International Isotopes Inc.

Subject: Response to NRC Request for Additional Information – Applications for Sealed Source and Device Registrations for Models BM10 and BMCY/BMNT Photon Emitting Sources.

Application for Safety Review
 INIS 022409 - Model BM10 Series

Attachment 1 Drawing B1001000

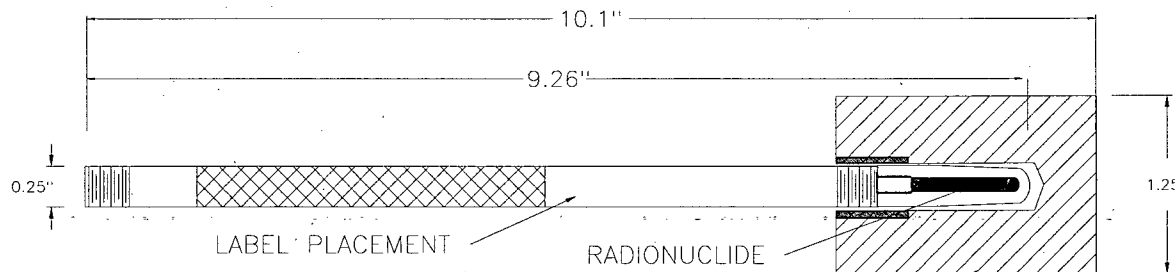
2.1. Please provide complete details of the labeling of the product, including information contained on the label and how and where the label is attached. Specifically, address whether the information is engraved or a separate label is attached on to the source. If attached, please describe the method of attachment.

3.2. Please provide information on maximum allowable temperature, vibration, shock, handling, storage, and transport.

- 6.1. Please provide non-proprietary illustrations similar to drawings B1001000, B1009001, and B003005, preferably in electronic form, that are suitable for inclusion in the registration certificate.

Response to A. 2.1: Each source and storage shield is conspicuously labeled with the radioisotope, the activity, the reference date (MM/YY) a unique serial number, the radioactive tri-foil symbol and the words, "Caution Radioactive Material". The surface of this label material is a combination of rubber (latex) and paper. Below the surface is a thin film barrier coating to provide added strength. The material is flexible and water resistant. The label has an adhesive backing. Once applied to the source and shield a second clear label is applied over the data label to ensure the data remains legible throughout the life of the source. Refer to Drawing B1001000 for label placement. There is no intention to engrave the source.

In regards to handling and storage; the description of the source provided in the application as well as Drawing B1001000 indicates that the radionuclide is confined to the tip of the rod (the pointer). When not in use the pointer is threaded into the shield, this is the storage configuration. When the source is in use it is intended to be handled at the end opposite the pointer (the non-active end). The non-active end is threaded as well so that the shield can be threaded onto this end were it can act as a stand and to allow for the source to be handled comfortably in the palm of the hand. Note that a sufficient amount of distance between the pointer and the non-active end of the rod reduces the dose to the extremities when the source is being handled as intended with the pointer out of the shield. International Isotopes, Inc. distributes these sources to customers licensed by the NRC or an Agreement State or when sources are exported, licensed or authorized by the appropriate foreign authority.

Response to A. 6.1: Comment addressed in Response to A.5.1. Also note that Drawing B1001000 is intended for inclusion in the registration certificate. Drawings B1009001 and B003005, while authorized for public disclosure were included in the application package as part of the testing documentation and are not applicable and should not be included in the registration certificate.

Attachment 1 BMCY-68 Phantom Drawing

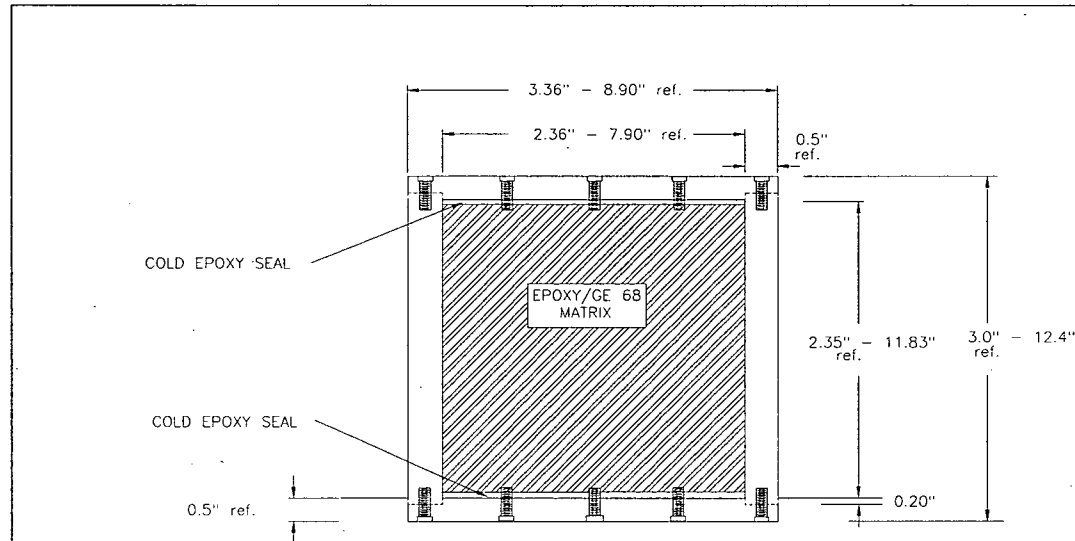
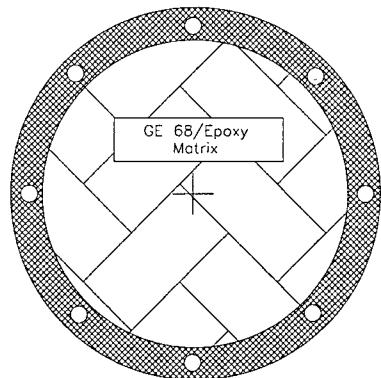
- 4.1. Drawings RAD020309-1 and B900101 are labeled as proprietary. Please provide information as required by 10 CFR 2.390(4)(1)-(v) with regards to withholding this information from public disclosure and please include a notarized affidavit.

- 5.1. Please provide non-proprietary illustrations similar to drawings RAD020309-1 and B900101, preferably in electronic form, that are suitable for inclusion in the registration certificate.

Response to A. 4.1: Following careful consideration, INIS and RadQual, LLC agree that the details contained within the drawing can be released to the public. New drawings are provided containing a statement to this affect.

Response to B. 5.1: Comment addressed in Response to B.4.1.

ITEM NO.	QTY	PART OR IDENTIFYING NO.	DESCRIPTION	QTY
MATERIAL PER DRAWING SPECS				
RADQUAL, LLC			POINT SOURCE MARKER ASSEMBLY DRAWING	
TOLERANCE		DRAWN: K. ALLBERG	DATE: 1/15/05	DWG. NO. B003005
JOK :		CHECKED:	APPROVED:	
FRACT. :		DATE:		
NEXT ASSEMBLY		SCALE: NTS		Sheet 1 of 1

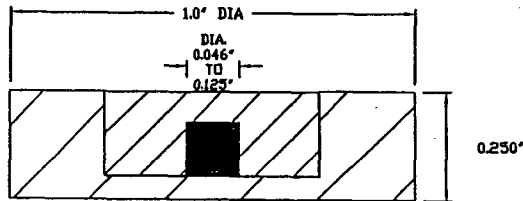
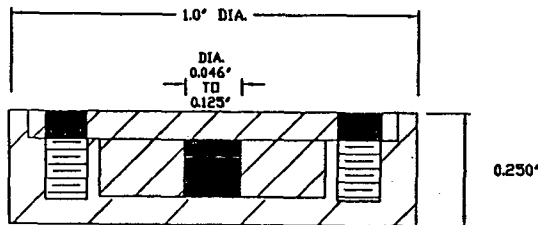
- 5.1. Drawings B1001000, B1009001, and B003005 are labeled as proprietary. Please provide information as required by 10 CFR 2.390(4)(l)-(v) with regards to withholding this information from public disclosure and please include a notarized affidavit.

Response to A. 5.1: Following careful consideration, INIS and RadQual, LLC agree that the details contained within the drawing can be released to the public. These drawings are provided containing a statement to this affect.
